Addendum No. 1
February 22,2021

Project: Lincoln High School – C.I.P. Addition and Renovations PD#3311
Sioux Falls, South Dakota

Architecture Incorporated Project No.: 2901

DRAWING
SD1

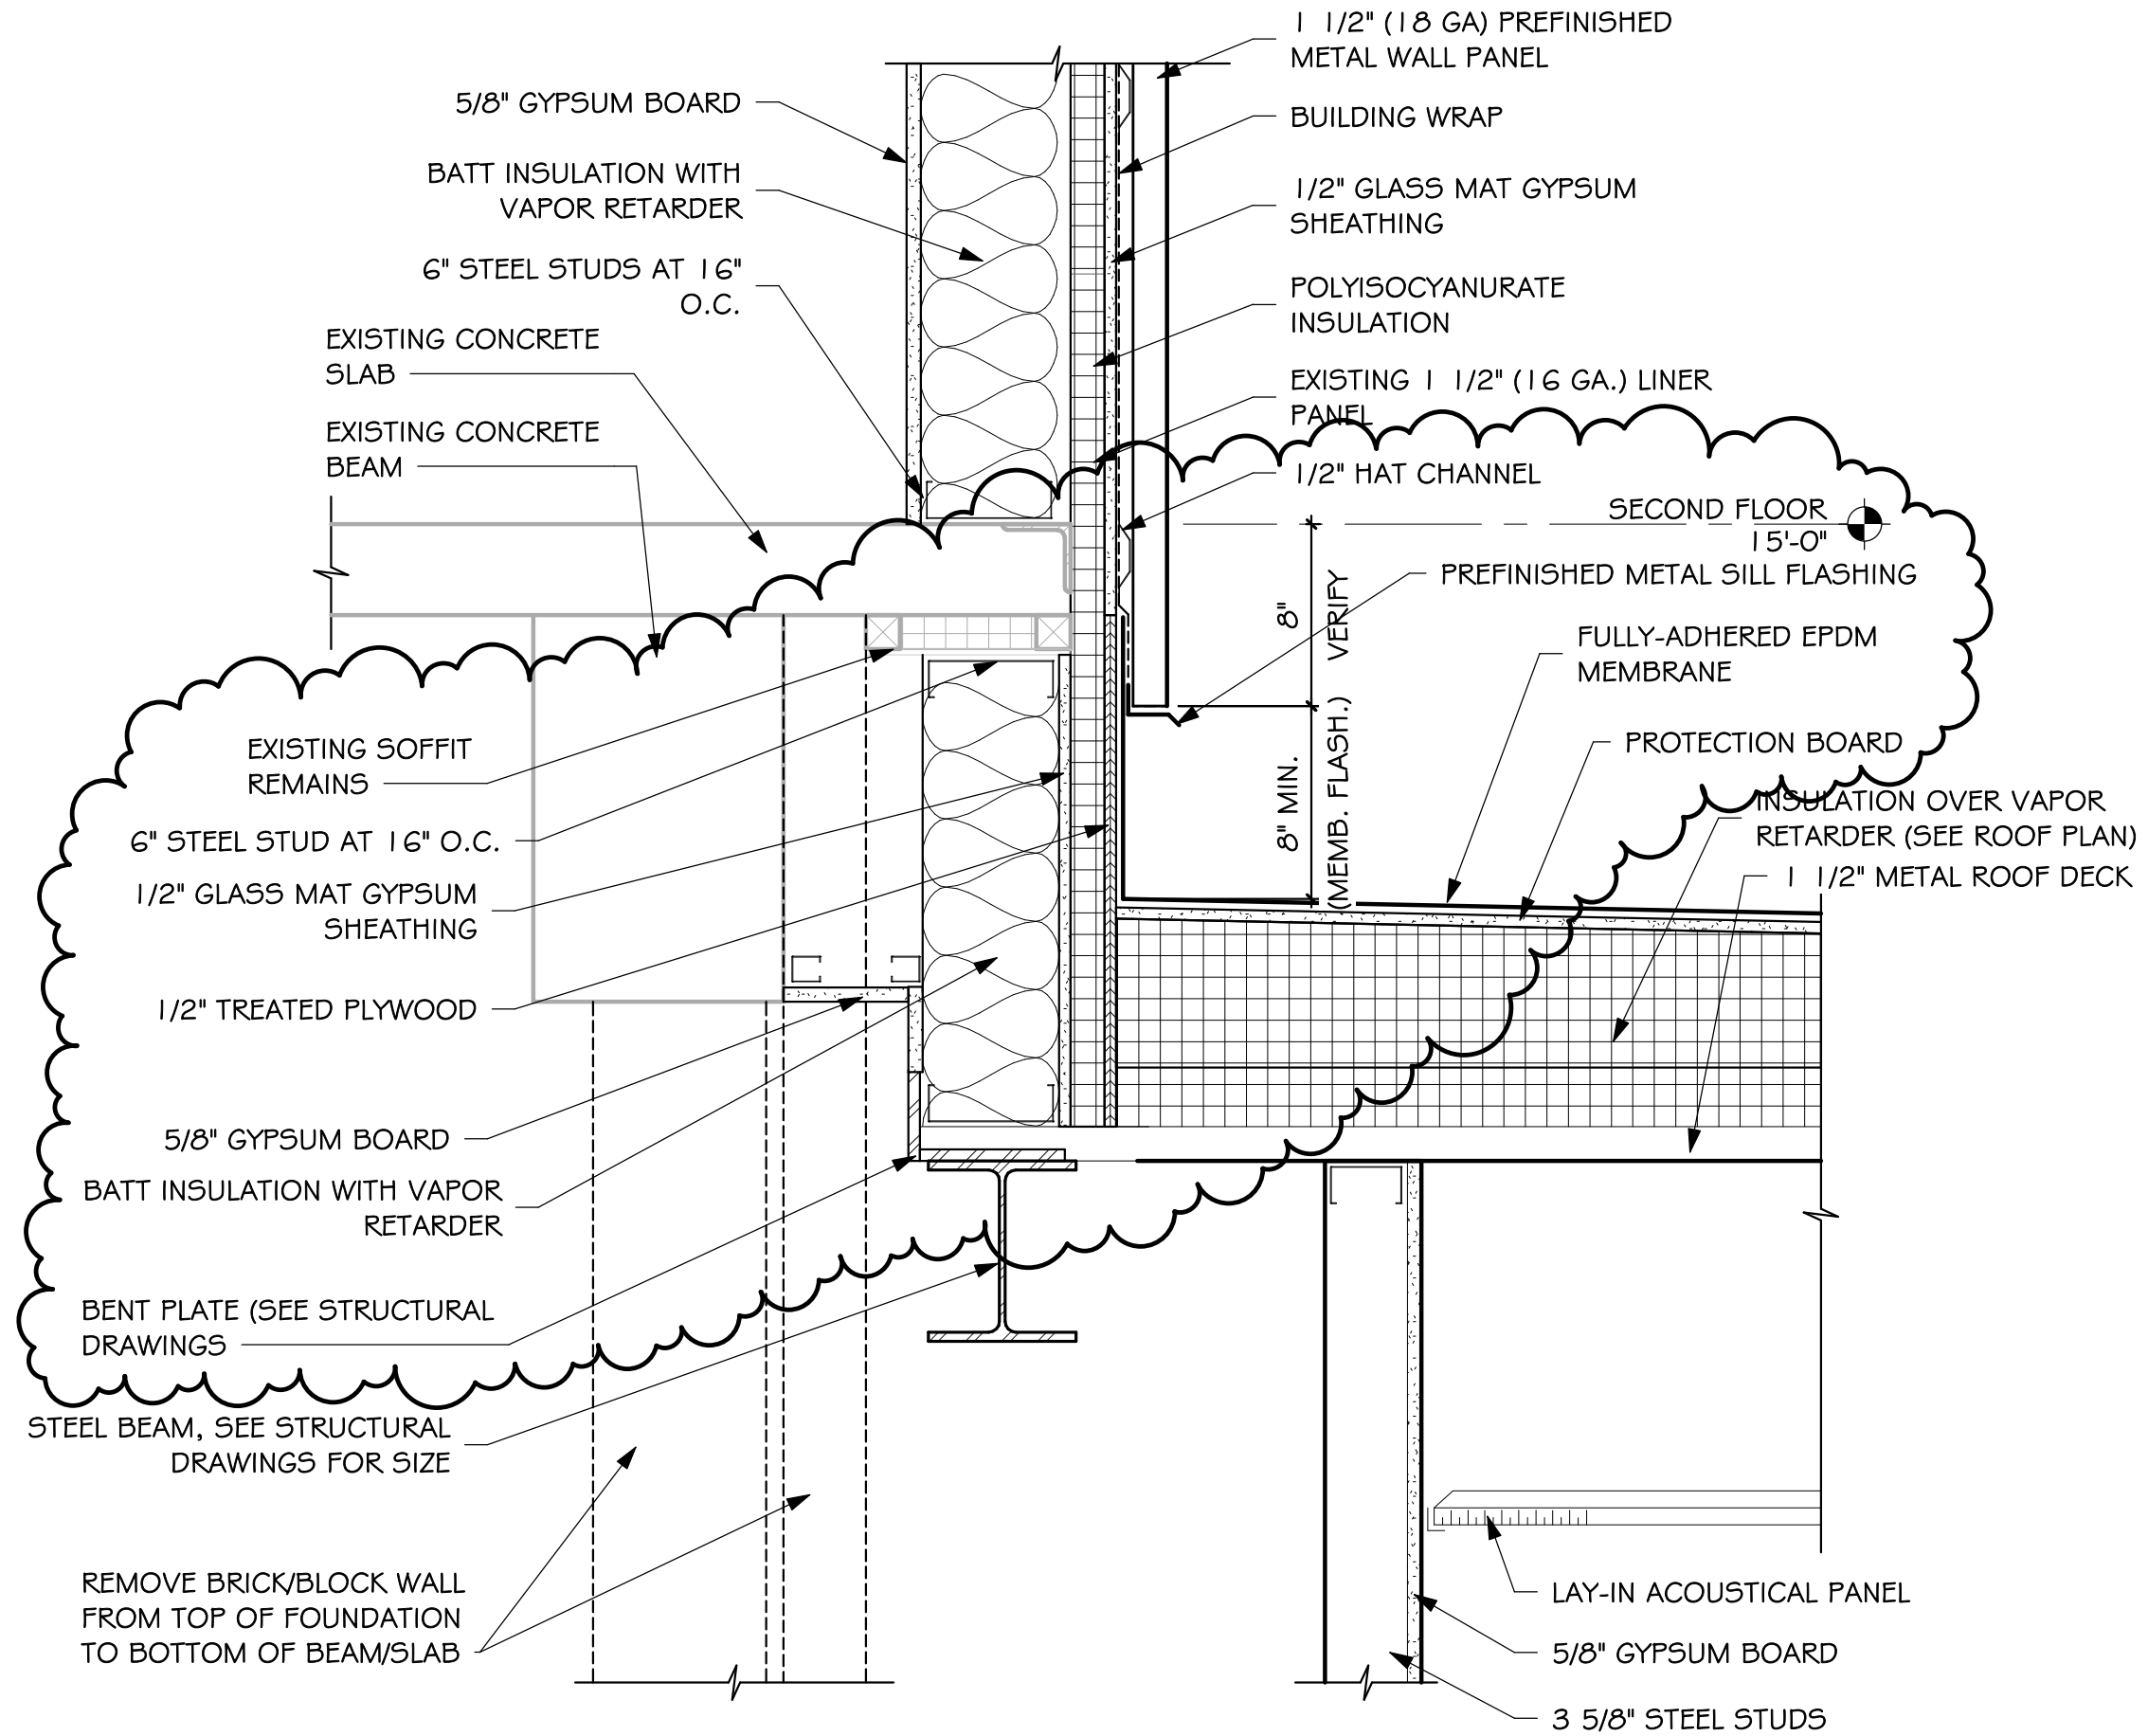
- a) Detail 3/5.21 – at ‘14’-0” TOM’ elevation reference, change the ‘~~12’-0”~~ ABOVE THE FLOOR’ to read ‘11’-4” ABOVE THE FLOOR’.
- b) Reference supplemental drawing SD-1 attached to the end of this addendum for revised detail 1/5.21.

DRAWING
SD2

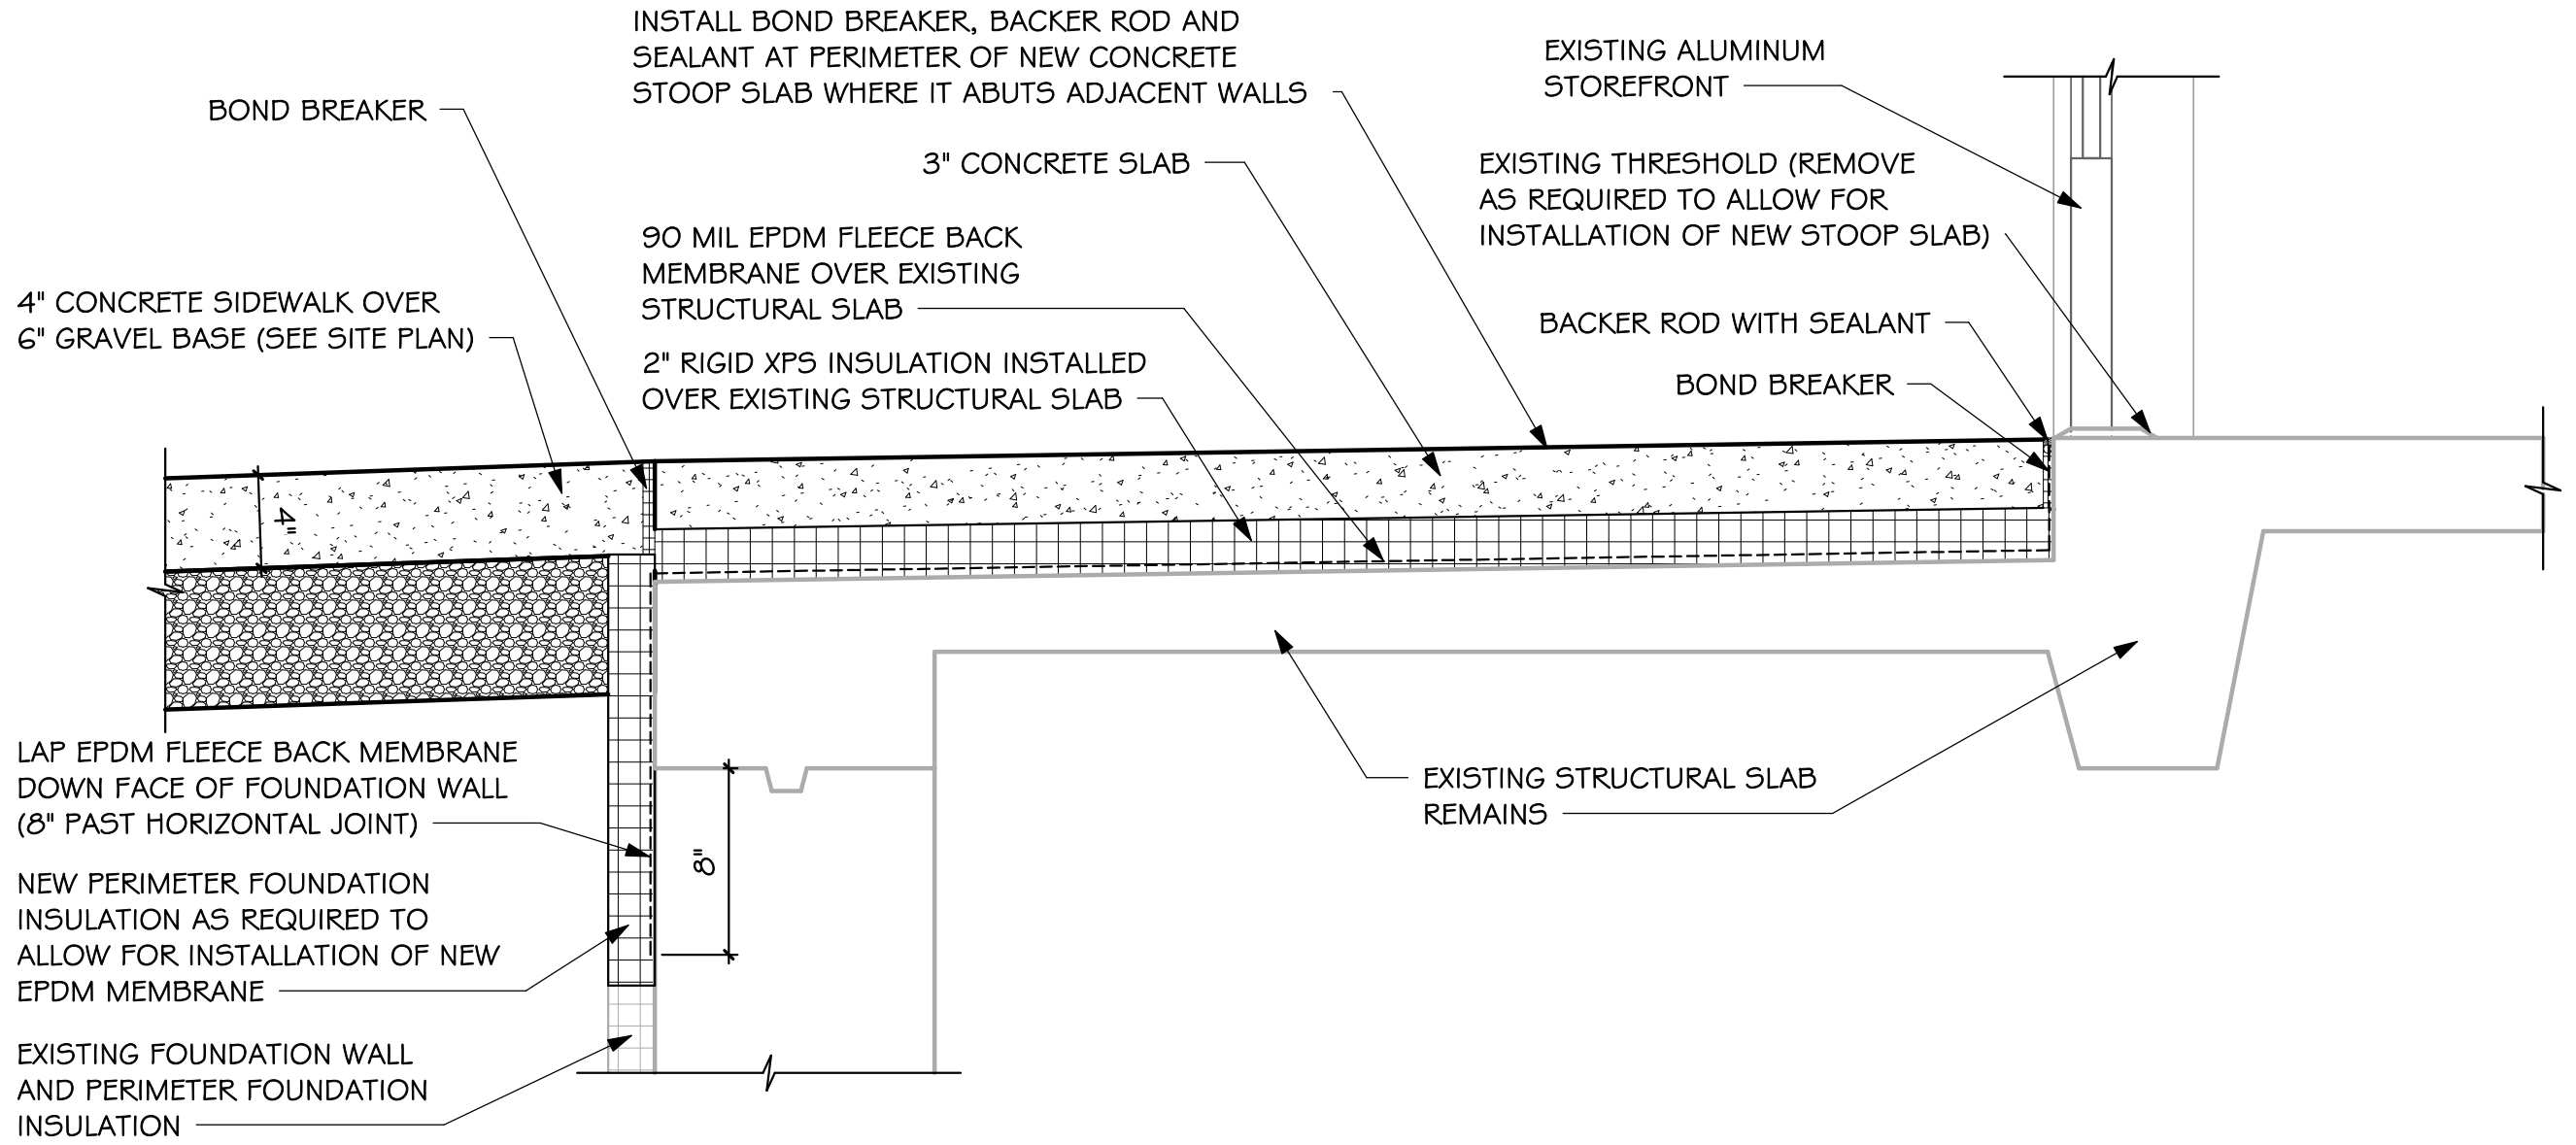
- 6) SHEET 4.12 – SECOND FLOOR PLAN – AREA E
- a) Change ‘*Auto Tech*’ room number from ‘E211’ to ‘E211G’.
- b) See attached supplemental drawing SD-2 (detail 7/5.21) for replacement of the concrete stoop slab, insulation, and EPDM membrane at existing north entrance door. Contractor to remove concrete slab, waterproofing membrane, and rigid insulation to allow for installation of new. Existing structural slab to remain.

- c) Reference supplemental drawing SD-2 attached to the end of this addendum for stoop slab detail 7/5.21; see detail that is keyed in at north end of corridor E207; reference floor plan Sheet 4.12.

DRAWING
 SD3

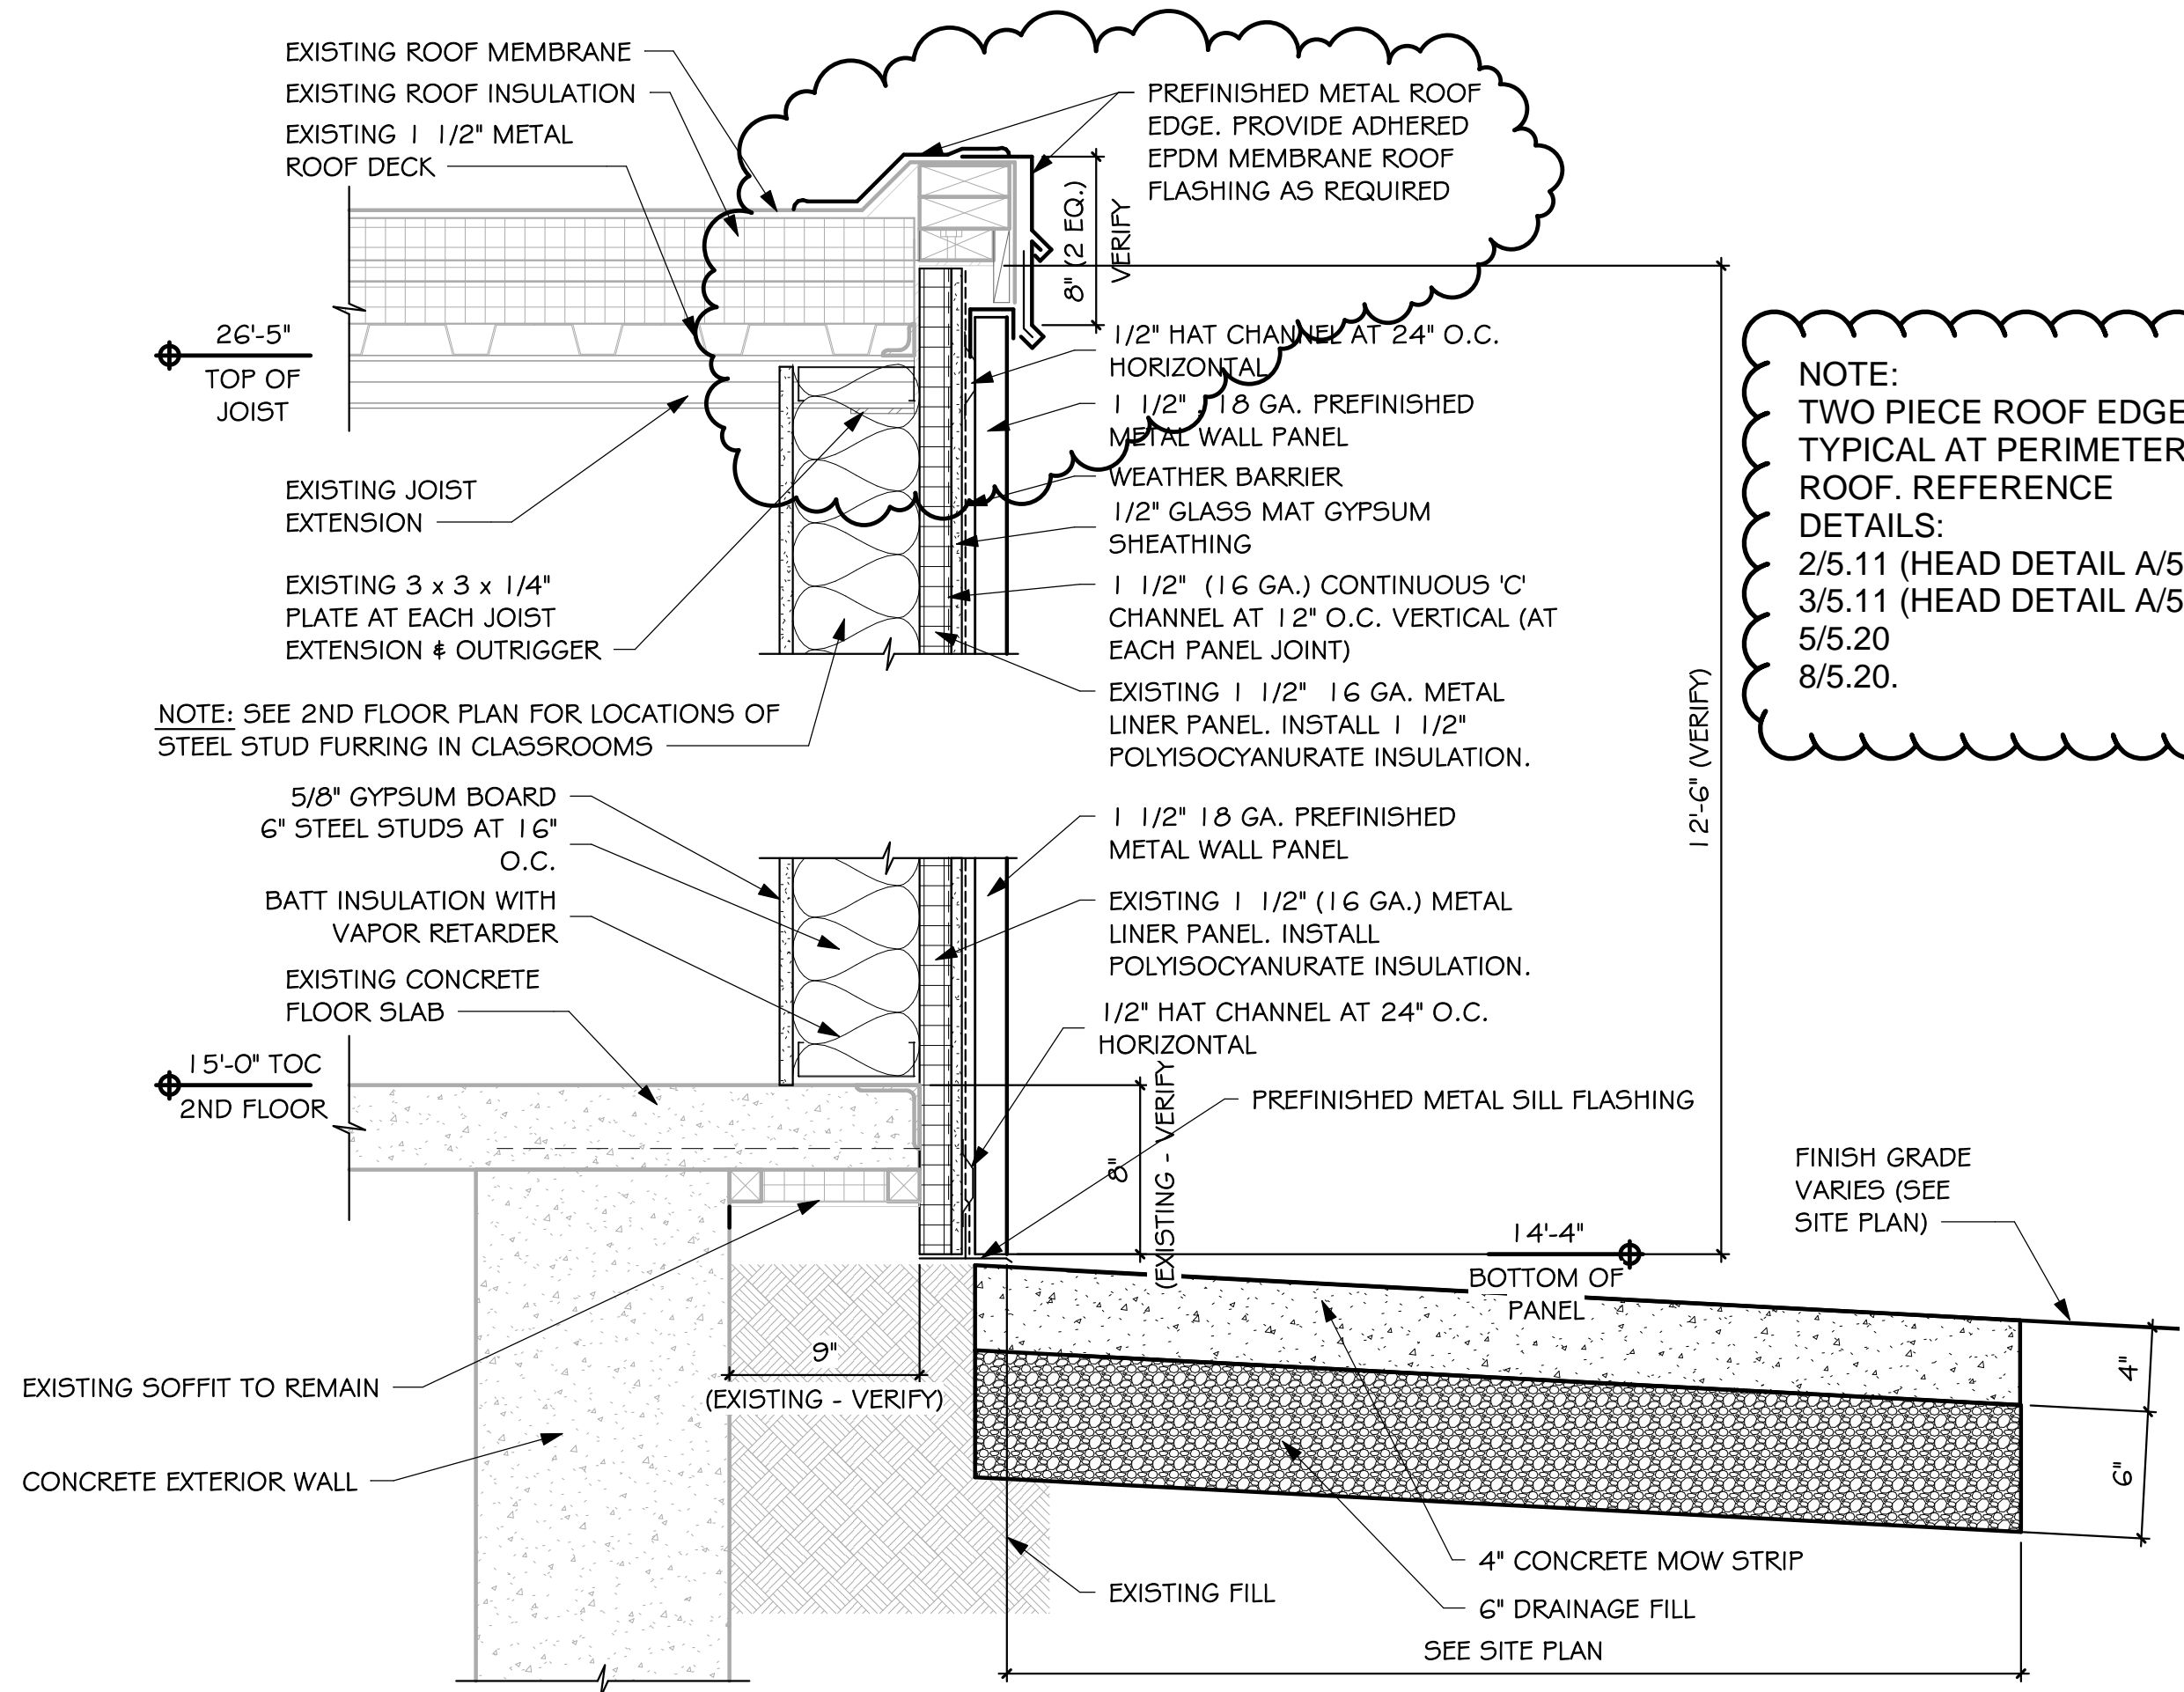
- 8) SHEET 5.11 – WINDOW DETAILS
- a) At window details 2/5.11 and 3/5.11 (head details A/5.11 at each), provide a two-piece prefinished metal roof edge to accommodate additional fascia height when insulation was added under a previous re-roofing project.

- i) Reference supplemental drawing SD-3 attached to the end of this addendum for revised detail 5/5.20 for two-piece roof edge profile.
- 9) SHEET 5.21 – SECTION DETAILS

- d) Reference supplemental drawing SD-3 attached to the end of this addendum for revised detail 5/5.20 which identifies a revised pre-finished metal roof edge detail.
 - i) Provide a two-piece pre-finished metal roof edge to accommodate ‘*modified*’ fascia height.
 - (1) NOTE: Additional fascia height occurred when additional thickness(es) of rigid insulation was added to the roof assembly during a previous re-roofing project.

NOTE:
 TWO PIECE ROOF EDGE IS
 TYPICAL AT PERIMETER OF
 ROOF. REFERENCE
 DETAILS:
 2/5.11 (HEAD DETAIL A/5.11)
 3/5.11 (HEAD DETAIL A/5.11)
 5/5.20
 8/5.20.
